ADDENDUM No. 01
September 7, 2016

AW Stanley Park and Aquatic Facility Improvements

New Britain, Connecticut
City of New Britain Bid Number 3896

The following changes and/or clarifications are hereby made to the Contract Documents dated August 22, 2016 for the above captioned project.

1 BATH HOUSE - TOP OF CMU PLAN
1/8" = 1'-0"

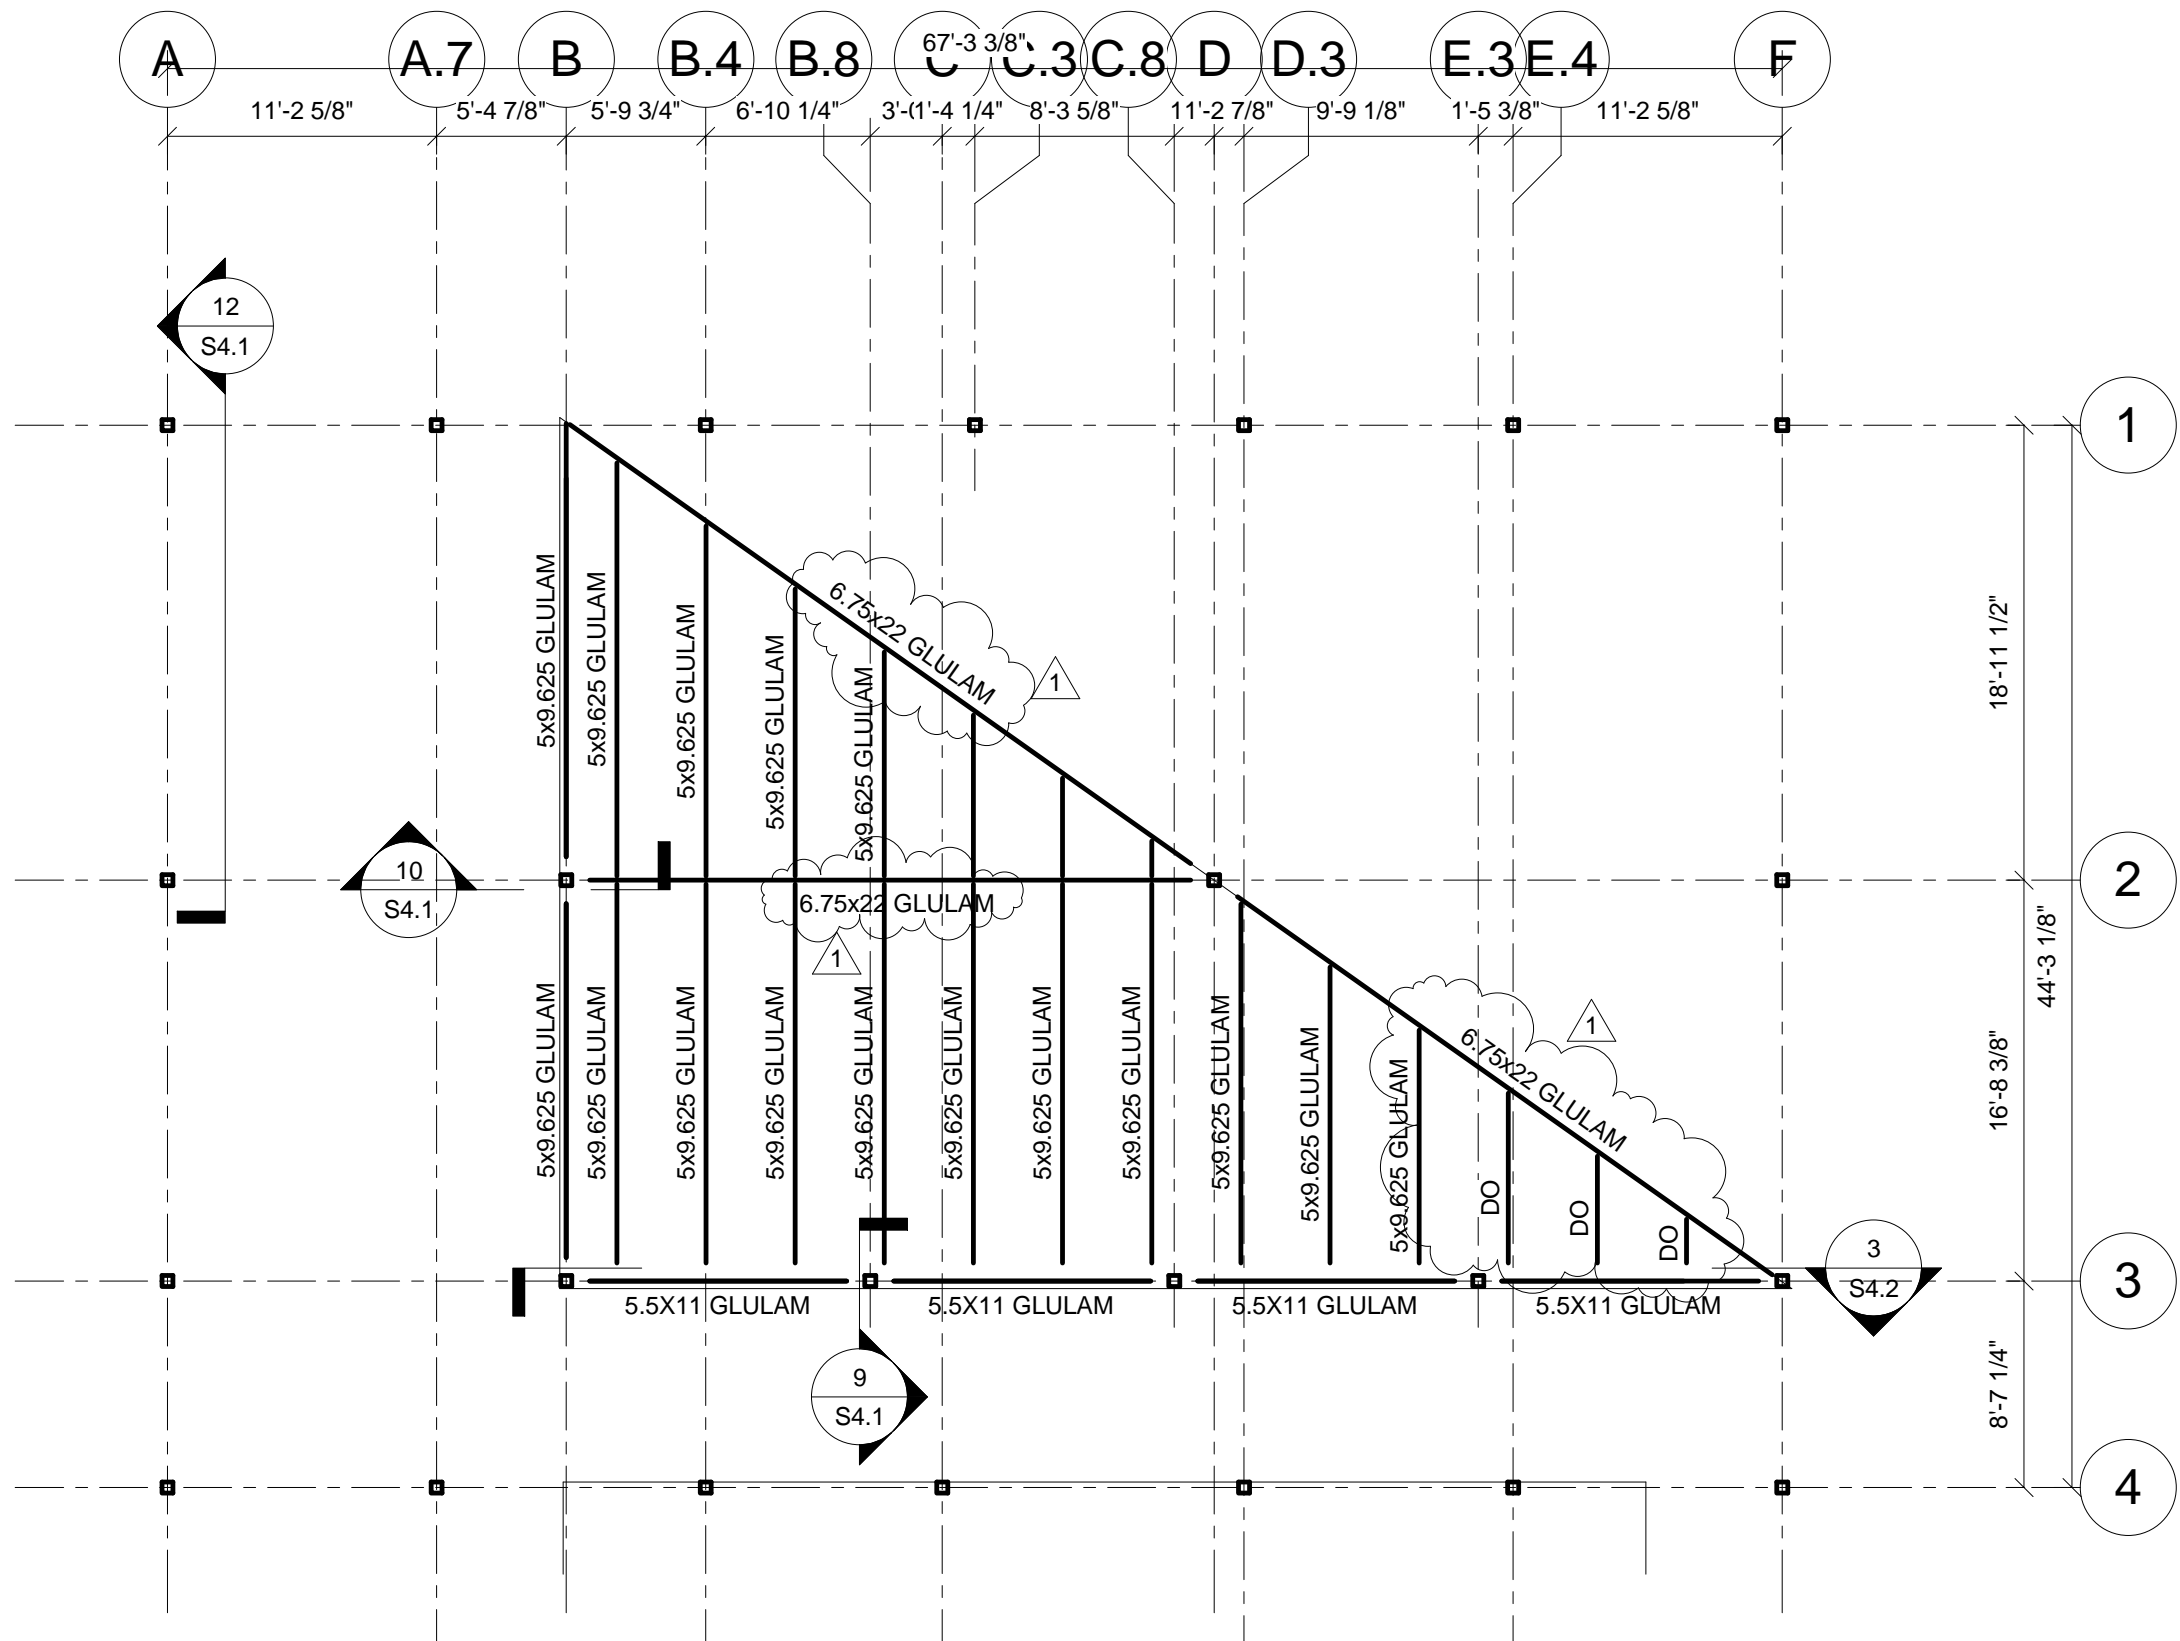
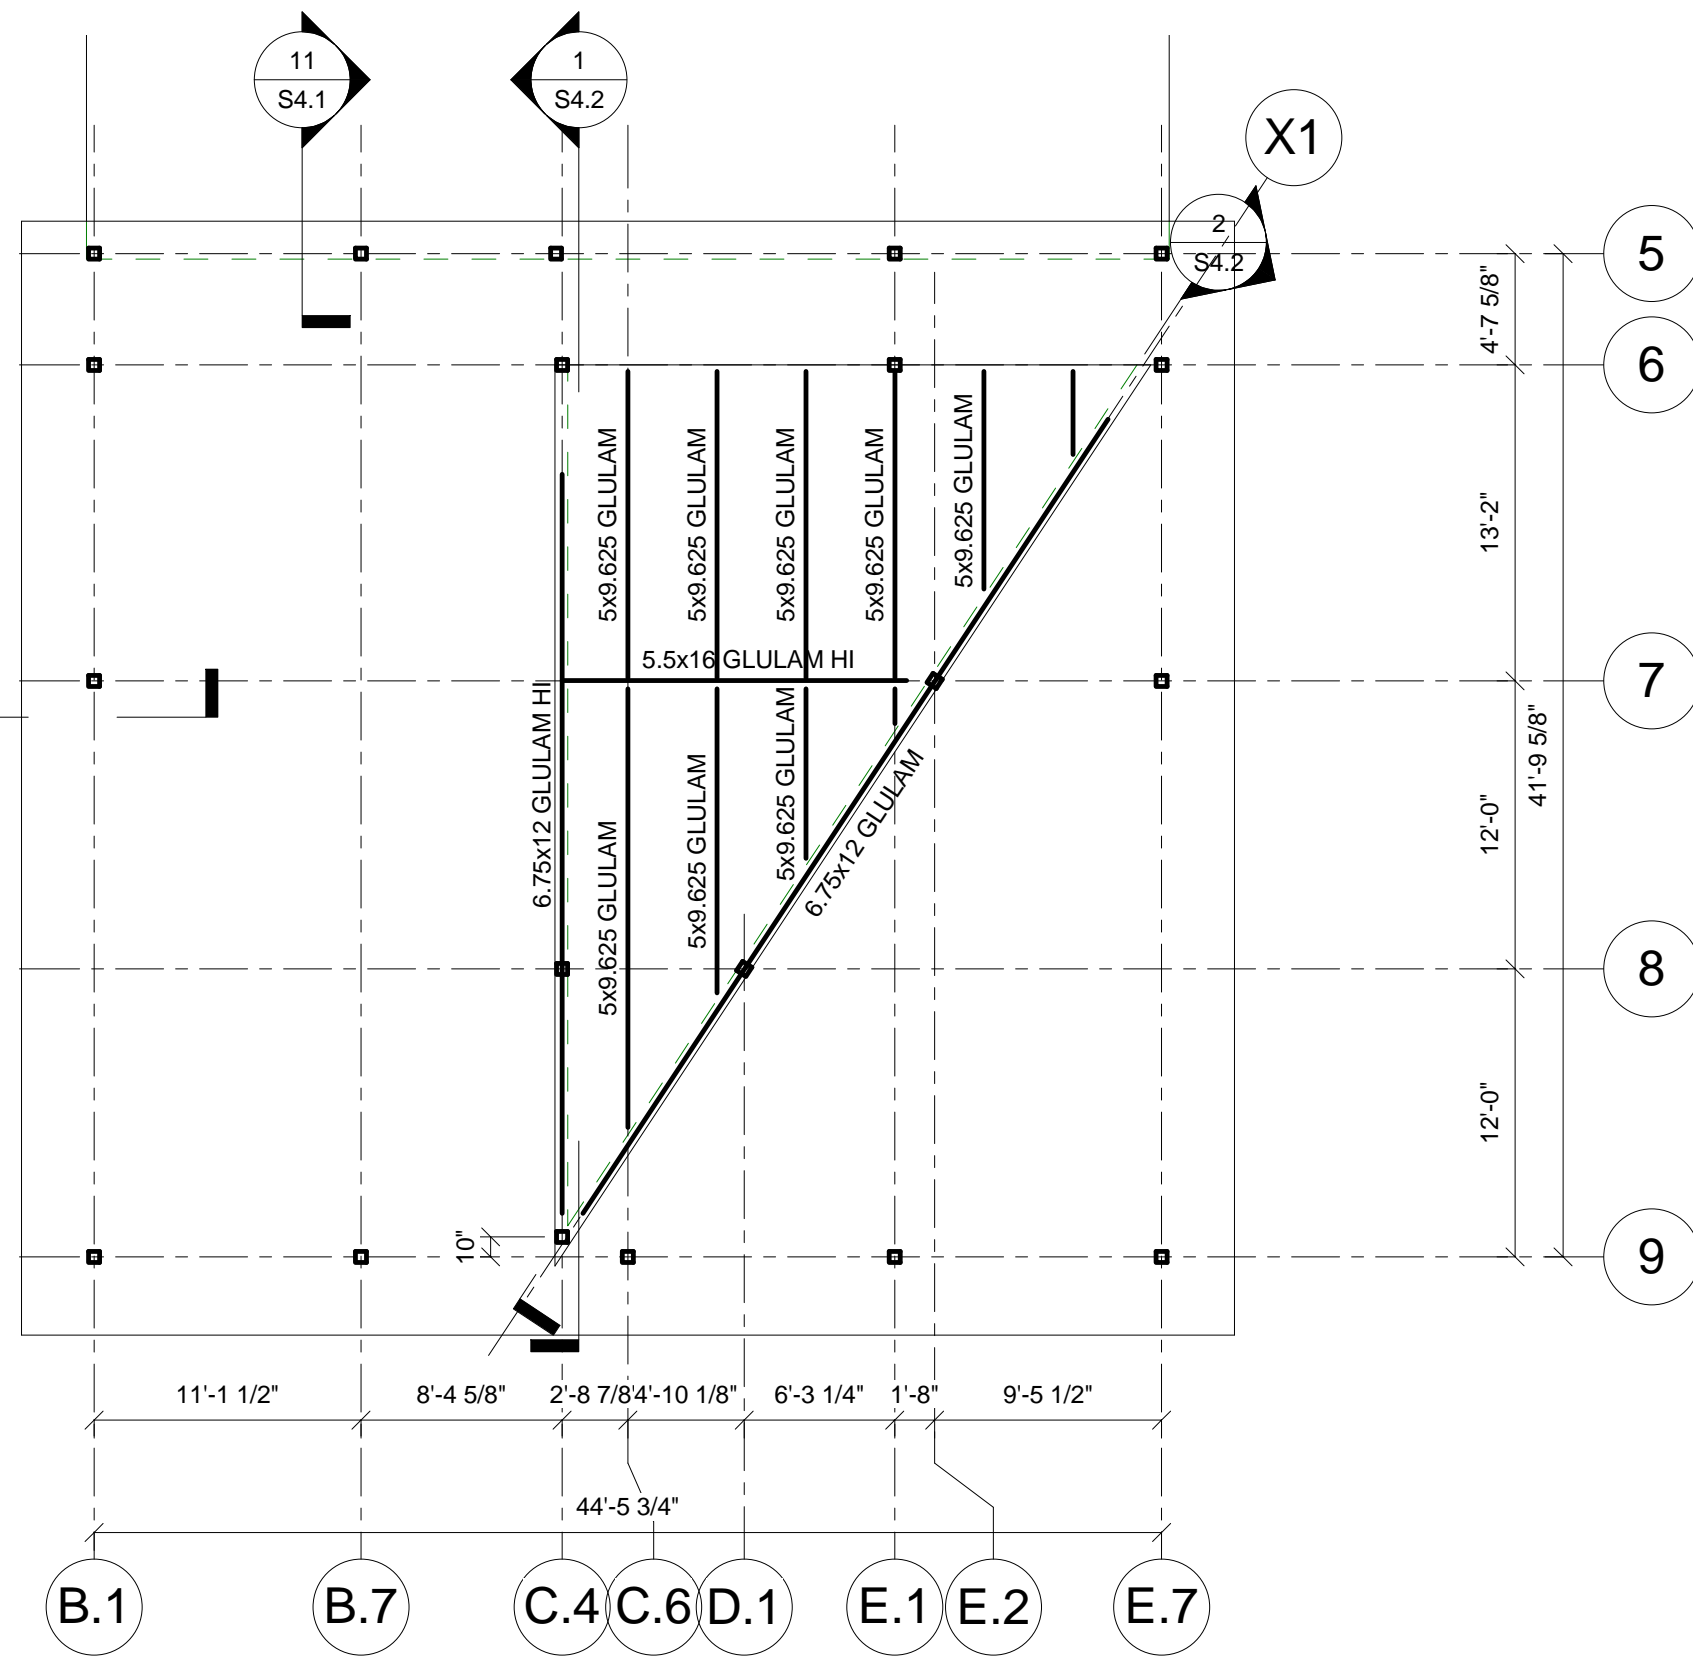
12) Drawing S1.1

- a) Add beam sizes as noted in SSK-S1.1-01, dated 9/7/16.
- b) Change SIPs Panel Dimension from 11 3/8" to 6 1/2". The underside of SIPs panel elevations shall remain unchanged. The thickness of the roof will be less and elevation call-outs and dimensions on building elevations, sections and details shall be adjusted accordingly.
